Technical Preservation Services  
Preservation Assistance Division  
National Park Service  
U.S. Department of the Interior  
Washington, D.C.

Interpreting  
the Secretary of the Interior's  
Standards for Rehabilitation

Volume III

4. Floor plan showing proposed insertion of apartments and removal of nearly all interior fabric.

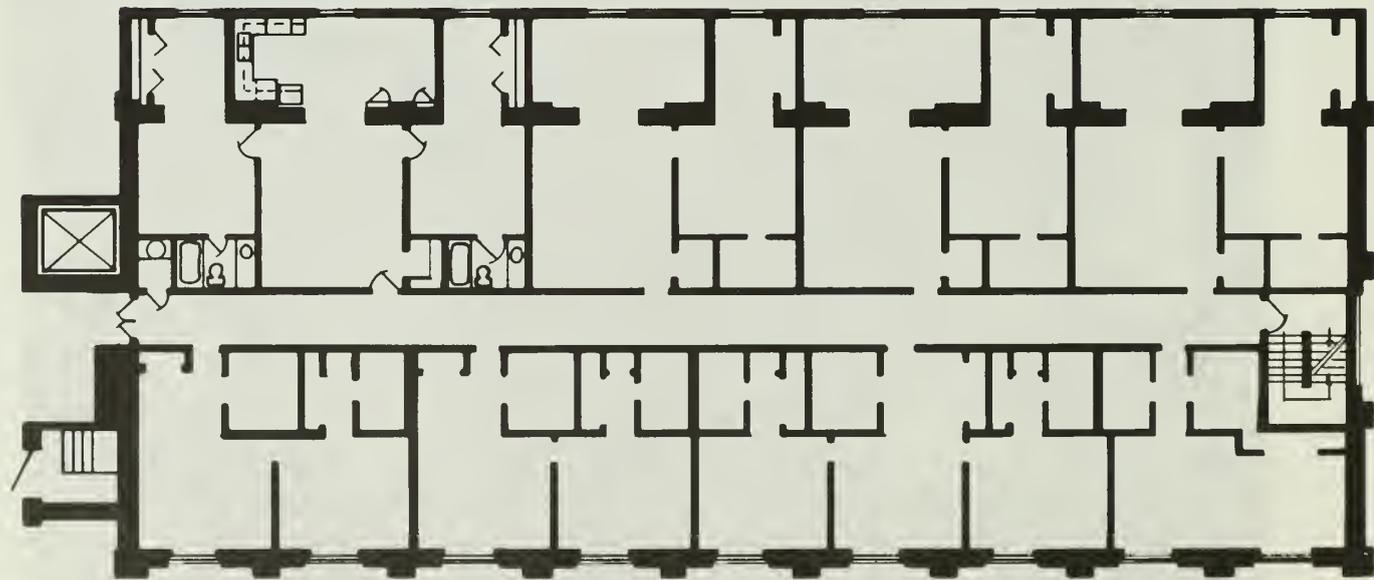
In denying the project certification, the regional office noted that the design proposal would remove:

all signs of the historic plan and structural system along with all interior historic fabric, i.e., stairs, balustrade and newel posts, lattice strap cell doors and riveted steel jambs, etc.  
Consequently, this proposal would erase all evidence of the essential form, integrity and sole intent of the building's historic appearance and purpose.

Considering whether this specialized building could be converted to housing, admittedly a difficult question, I have come to the opinion that it could have been reasonably successful with imaginative exploration of alternatives to total clearance of the interior of the cell block.

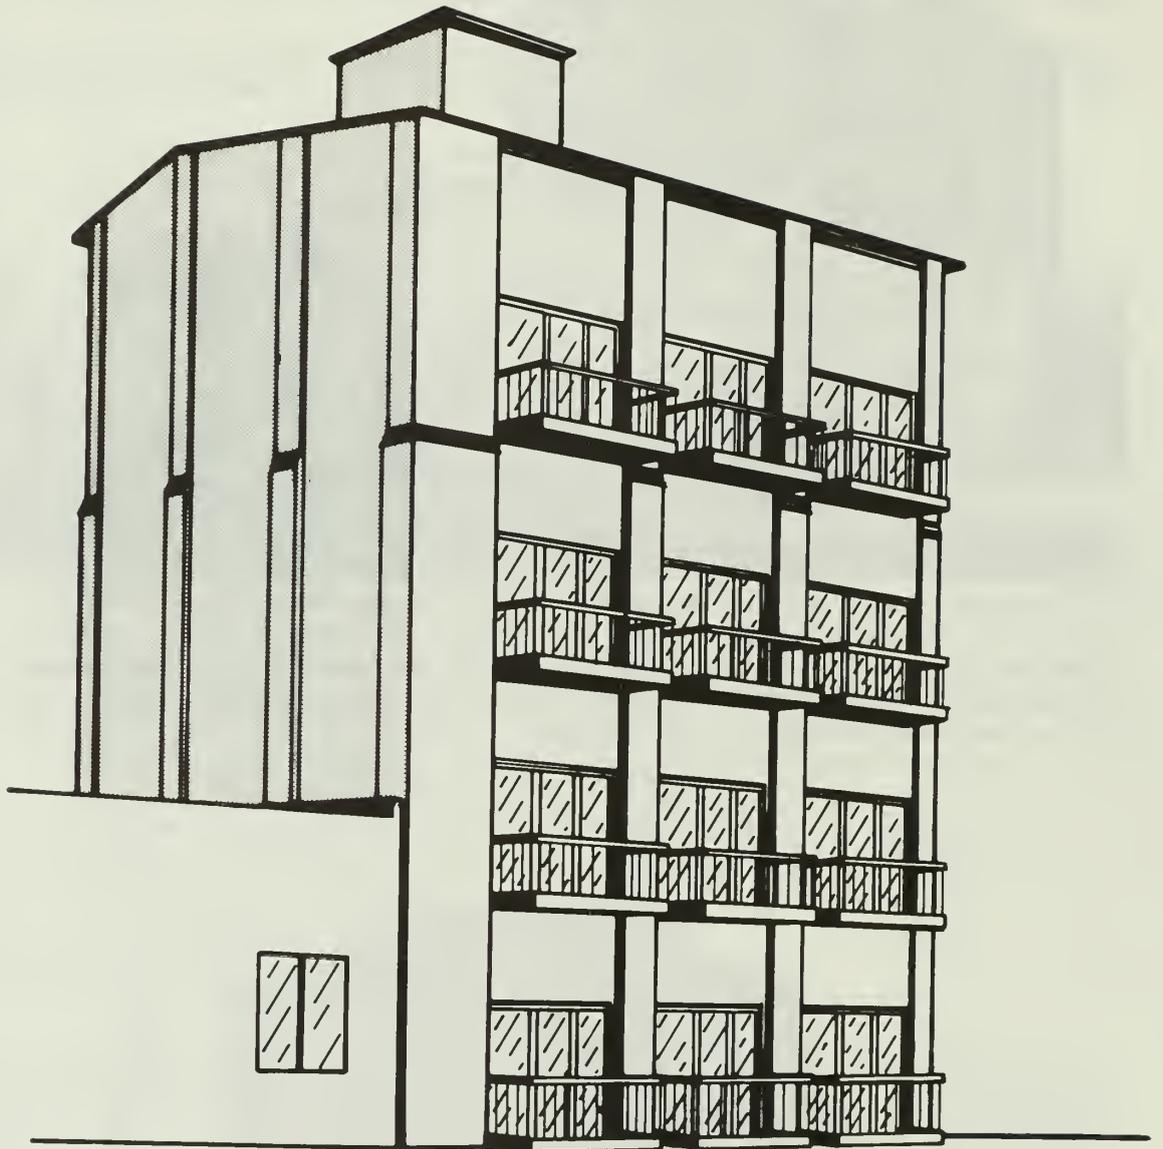
Conversion of an ice-storage building...which will probably be listed in the National Register as a rare example of its type...to use as an apartment building is a drastic change in use and requires too many significant changes to the fabric of the building. The distinguishing character of the main part of the building is inherent in the tall, solid brick walls, unrelieved except by pilasters, without window openings. Cutting window and door openings and adding balconies on four levels on the two long sides of the structure significantly alters the original character...The appended stair towers add to the changes...

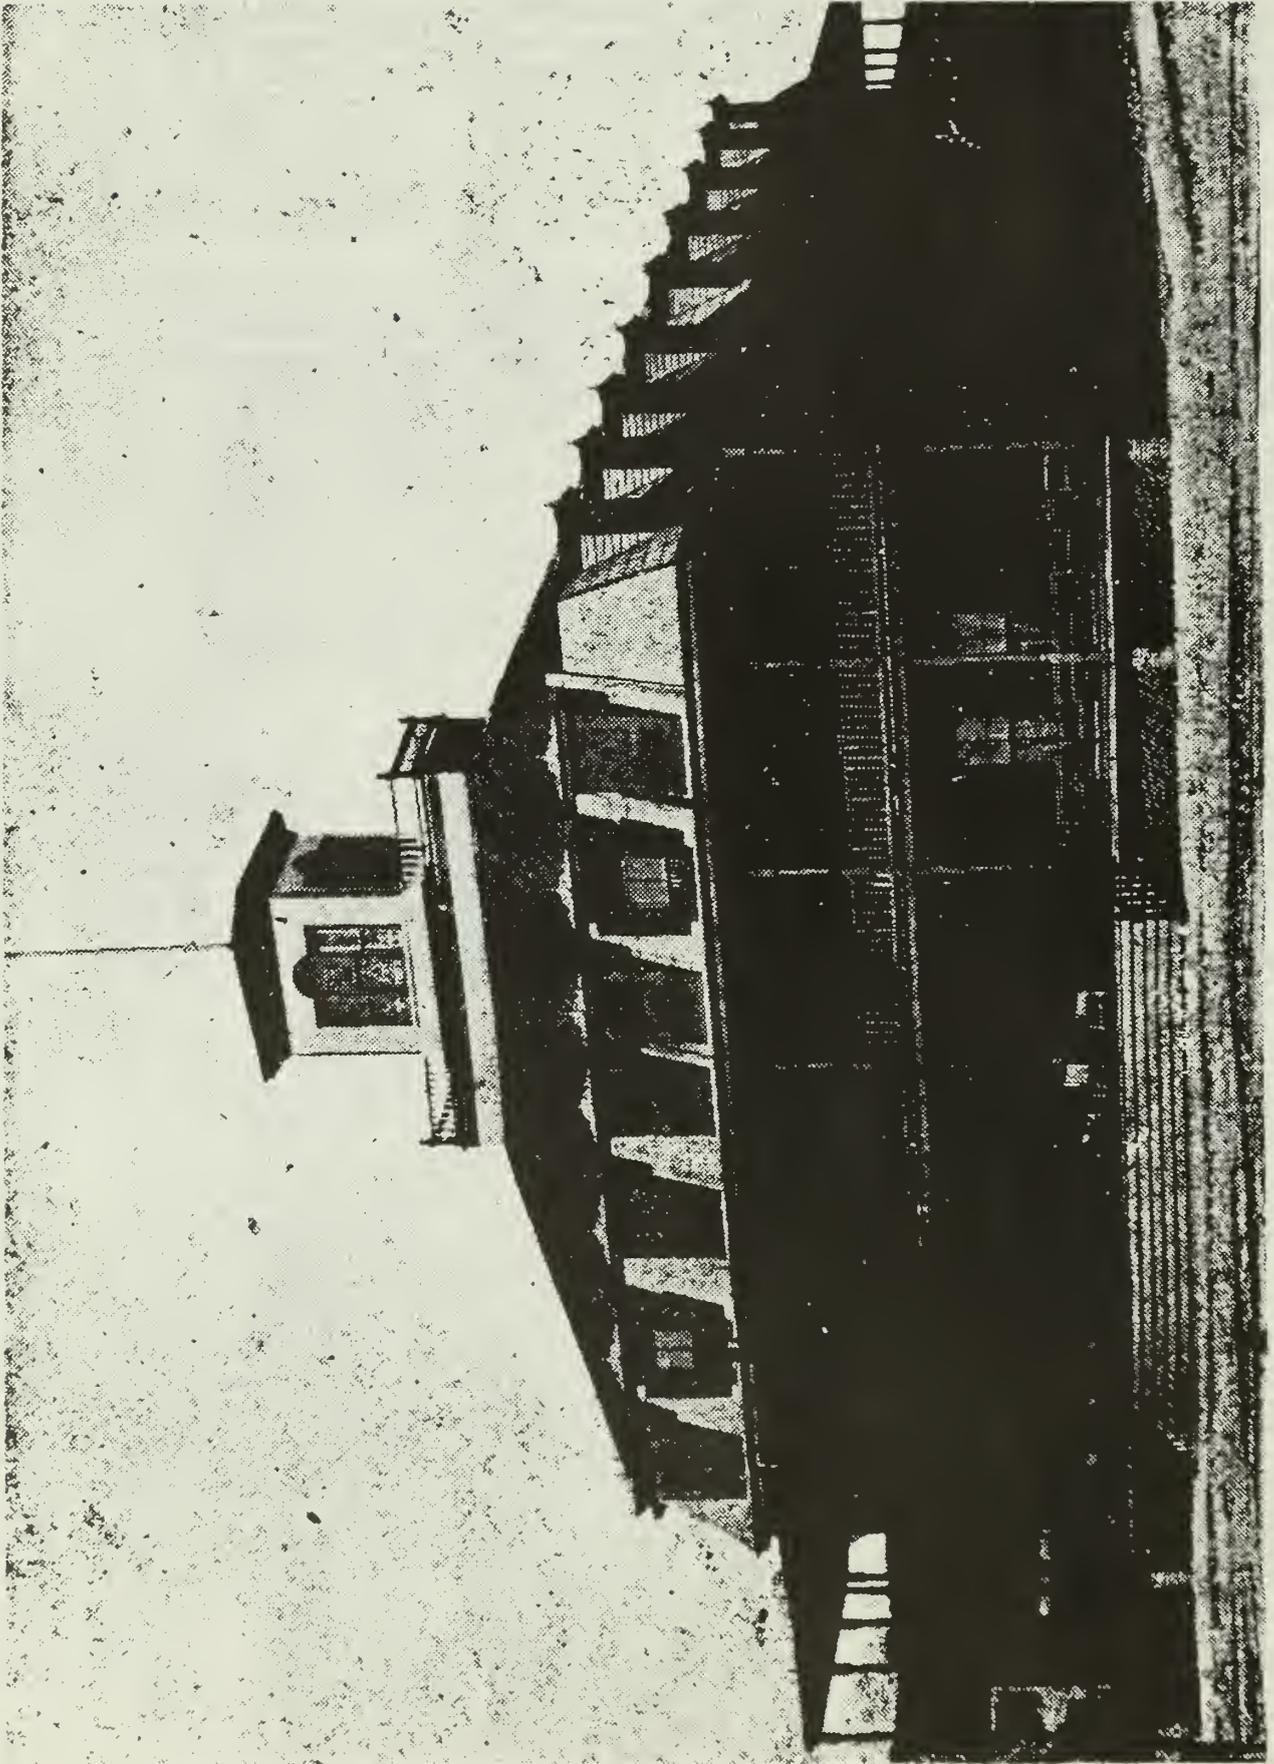
Rehabilitation of the hotel includes the restoration of two prominent significant features of the original hotel, its two-tier porch on all four facades and the central cupola surrounded by a balustrade. Pictorial evidence documents that these features existed in an earlier period; however, the building has evolved over time and the pictorial evidence submitted does not support restoration of the cupola...Restoration of the cupola would create a historic looking building that never existed...Restoration of the two-tier porch is similar to the cupola issue. Documentation does not show that double porches ever existed on all facades after the roof was changed...The cupola and porch proposals represent a selective restoration of original significant features and violate Standards 4 and 6.

During the course of our meeting you provided additional photographs...showing the building fully three stories high, with the later simplified roof line and with the double deck porch, but without the dormers and cupola. The emergence of this photograph offered a third option: to recreate the appearance of the hotel during this intermediate period in the building's history. However, comparison of this 1920 photograph with the views of the work "in progress" presented in the appeal shows that the 1920 appearance of the building has not been achieved...however, a cupola recalling the original cupola has (also) been constructed. The current rehabilitation, therefore, has given the building an appearance not known to have existed historically, for no evidence has been brought to light conclusively indicating that the cupola still existed after the roof had been changed to one slope and the walls had been raised to full three stories in height.

In the final paragraphs of this letter, the Chief Appeals Officer suggested that the project might be brought into conformance if the owner would agree to remove the cupola in order to restore the historically valid 1920 appearance of the hotel.

2. 2nd floor plan: Originally a side hall plan with 3 parlor rooms all of similar dimensions. Note extensive new construction in these rooms, especially stair and kitchen in center parlor room, and new wall for bathroom in rear parlor.

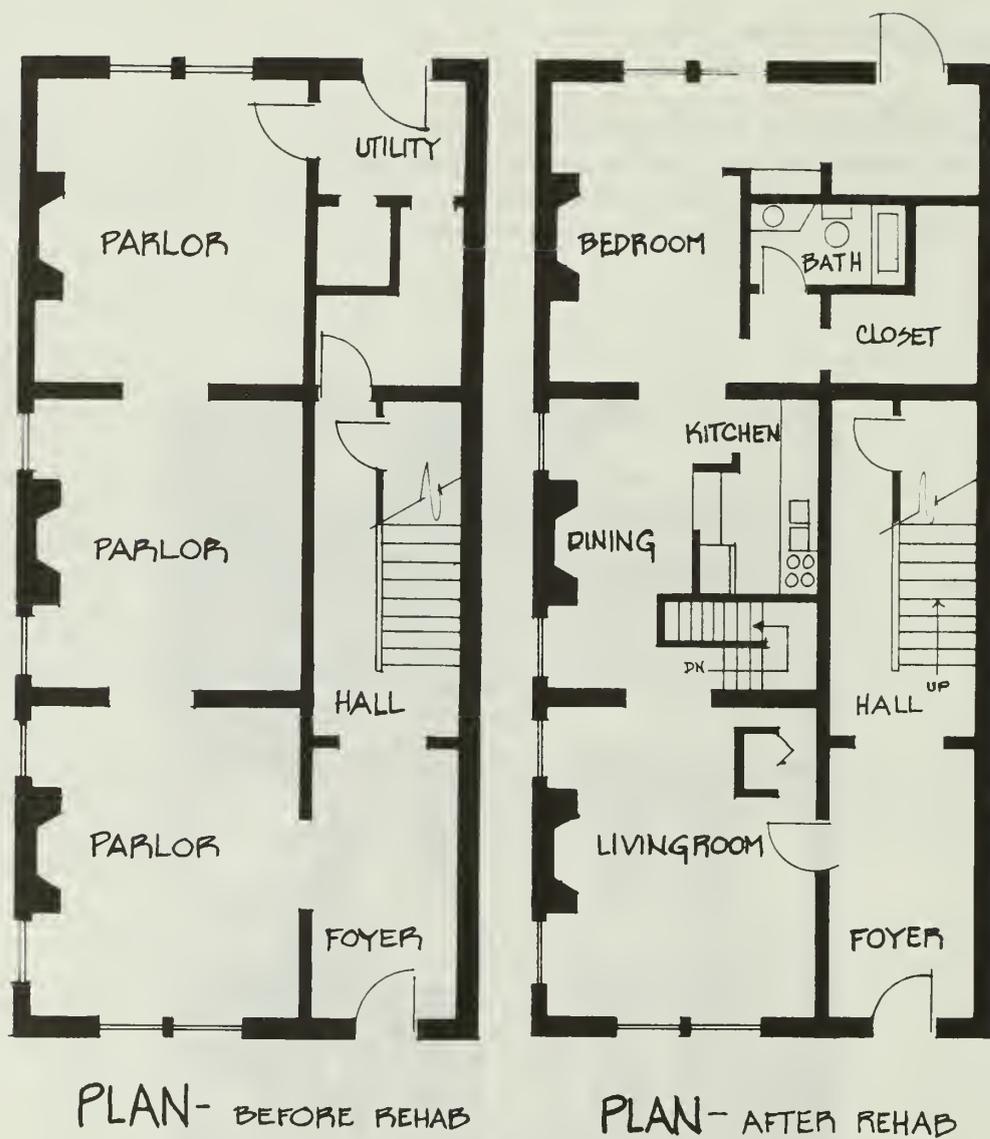
Although it is evident that efforts were made in the rehabilitation to avoid destroying ornamental features such as crown moldings and pocket doors, I find that the alterations have in fact damaged the overall historic character of this building's significant spaces. Although historic interior walls remain on the second floor and in the third and fourth floor hallway, large amounts of historic fabric nevertheless were sacrificed to allow for the new room plan on the third and fourth floors and for the intrusion of three new staircases in the building. I find the alterations to the parlor floor the most destructive. The three formal rooms, historically of approximately equal size, have been significantly altered by new construction. The new construction in the center room, effecting the most severe intervention in terms of the amount of new building and loss of historic fabric, has further altered the original spatial qualities of the second floor overall. Although the rear room is still partially visible from the front room, I find the new kitchen wall and stair balustrade in the center room so invasive as to destroy the sequence of space that this series of rooms was consciously designed to envelope. The alteration to the parlor floor is sufficiently

damaging to the character of this building that I would have upheld the regional office on that change alone. Therefore, it is my determination that the rehabilitation is not consistent with the historic character of the building and that it fails to meet Standards 2, 5, 9, 10.

6a and 6b. After rehabilitation floor plan of 1890 building. The unit on the left now extends across the full width of the building in the rear half. To regain the floor space thus lost in the right unit, a stair was added, further altering the plan of this simple structure.

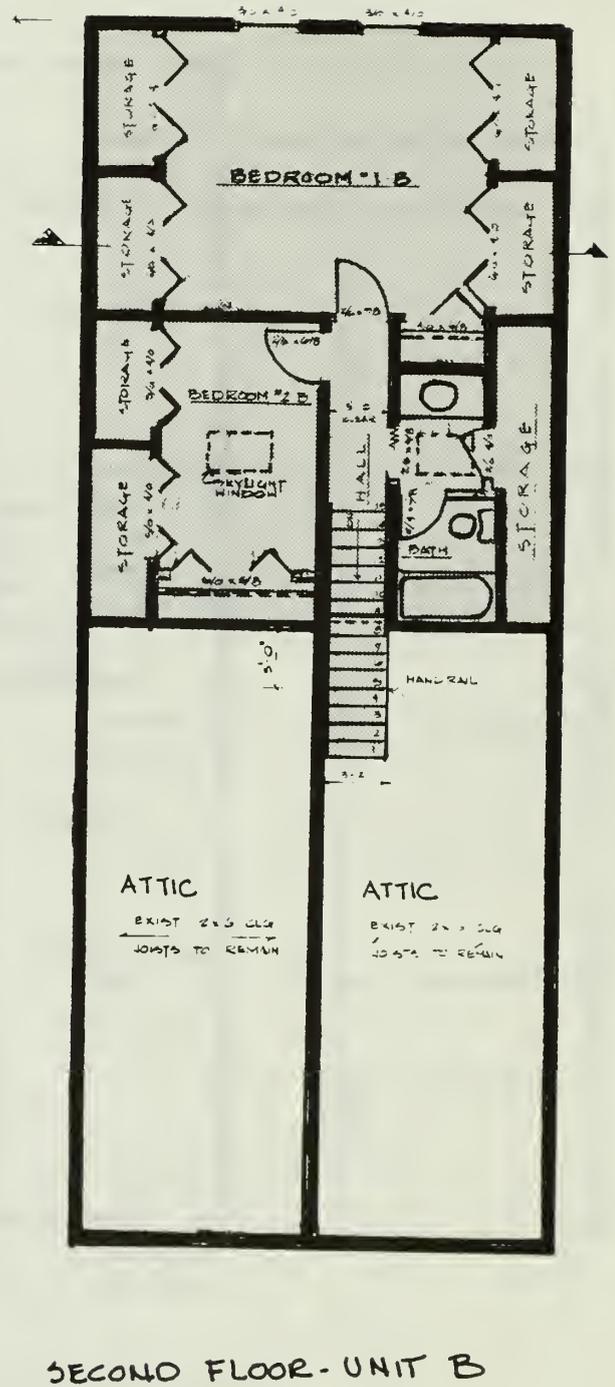
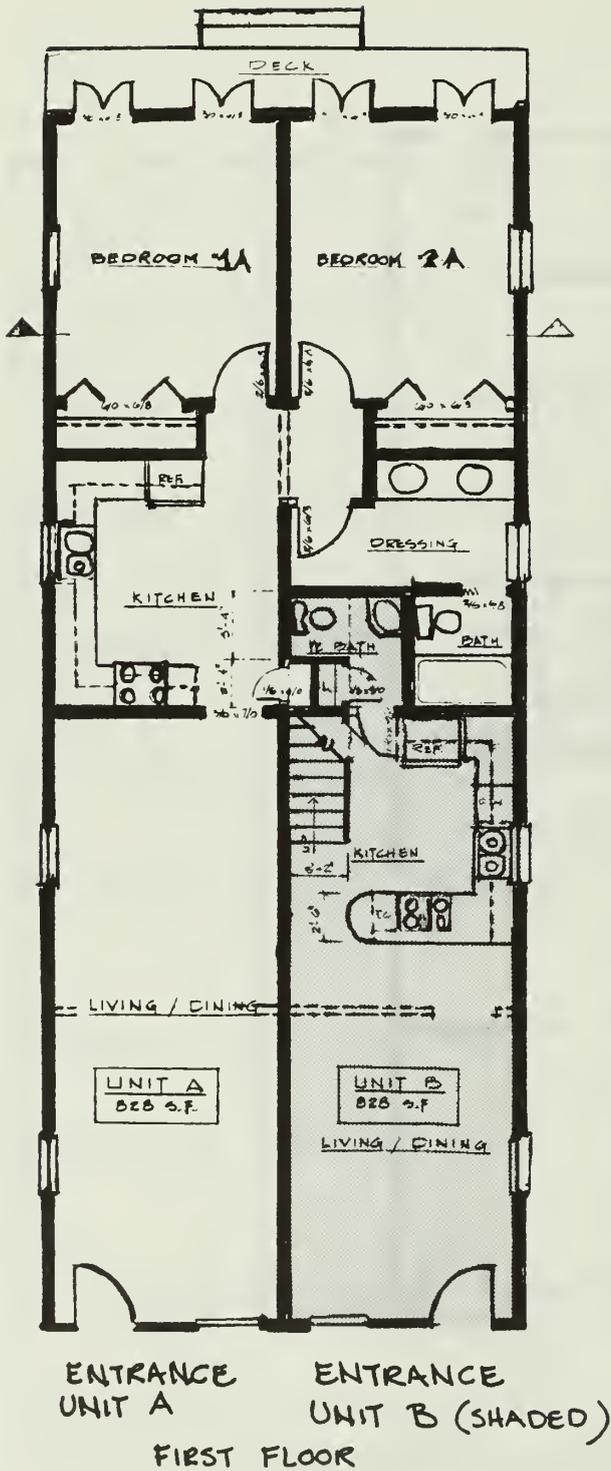
In the second case, radical changes made during the rehabilitation obliterated the characteristic interior plan (see illus. 6). The separation between the two front rooms was destroyed to create one larger room in place of the double parlor arrangement. In

order to enlarge the apartments, the plan was further altered by incorporating almost the entire rear half of the right unit into the left unit. The floor space lost to the right unit was regained through the addition of a stair to the attic, into which two bedrooms were added. In this project the damage done to the historic character of this modest building is extreme. The units no longer convey a sense of the original "shotgun" plan. Construction of the stair in the right unit has further drastically altered the structure by introducing a vertical element missing from the historic plan. Finally, the division between the halves of the building was effectively destroyed in the rear half of the building. Accordingly, the project fails to meet the Secretary of the Interior's "Standards for Rehabilitation."
